BRUSHCUTTER ATTACHMENT BCA850
(967185901)

Illustrated Parts List - IPL Update

BCA850

ATTACHMENTS

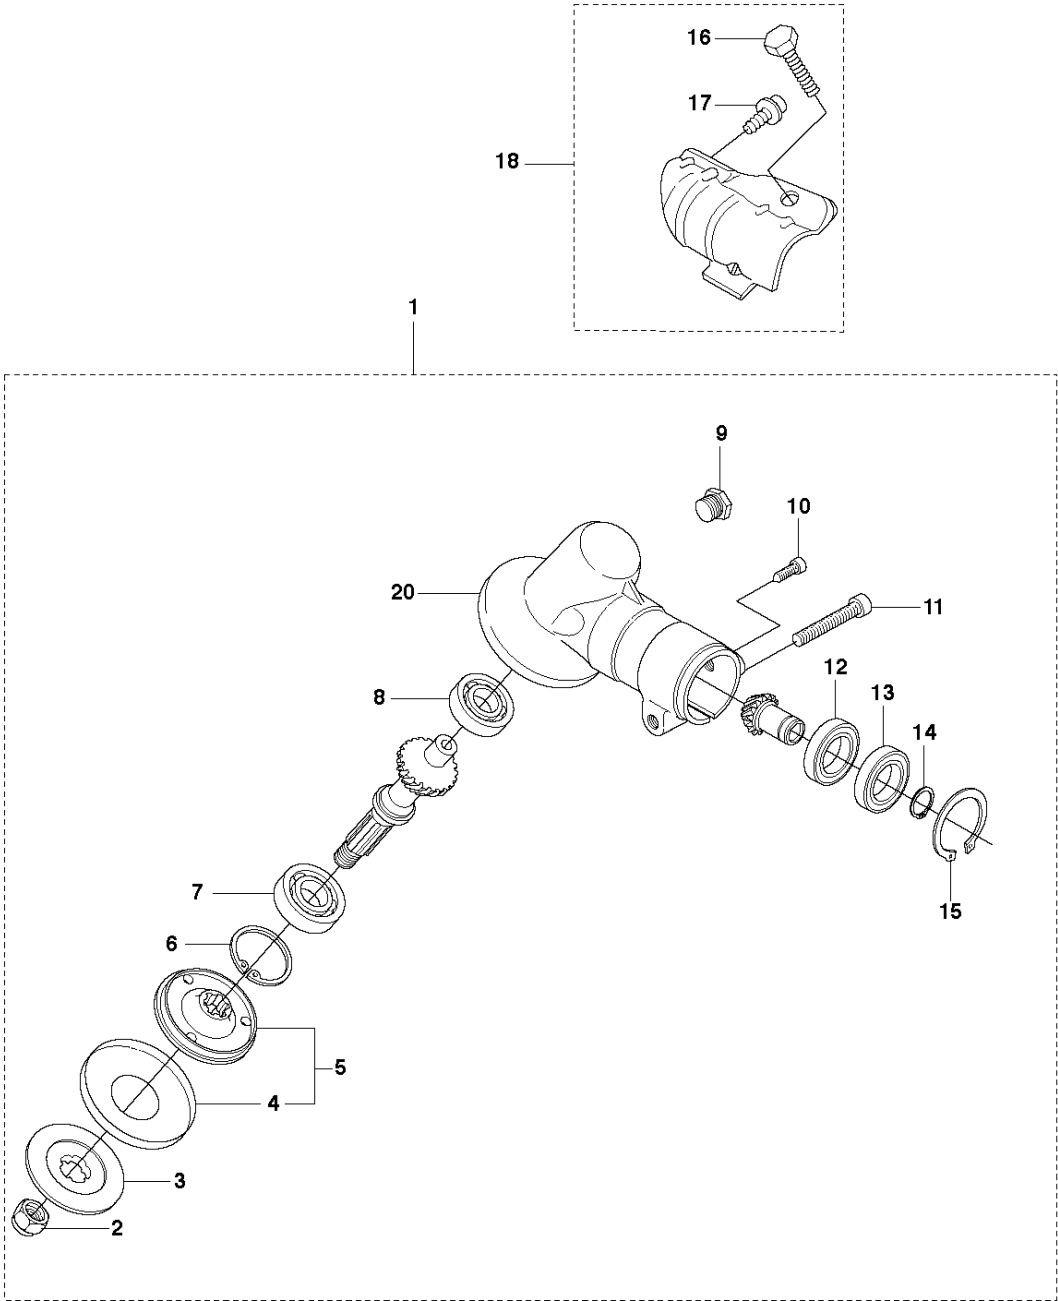
New tube assy, with updated plug, drive shaft and a clip, for an easier assembly (Click-on function)

Drive shaft 587 41 17-01 and plug 587 41 46-01 are backward compatible.
NOTE: Clip 583 93 83-01 does not fit with plug 544 37 87-01 and drive shaft 537 01 19-01.

Page title	Ref. no	New part no	Name	Excl. part no.	Remark
Attachments	1	587 98 81-01	Tube assy	537 07 99-02	
Attachments	4	587 41 46-01	Plug	544 37 87-01	
Attachments	6	587 41 17-01	Drive shaft	537 01 19-01	
Attachments	26	583 93 83-01	Clip		New part
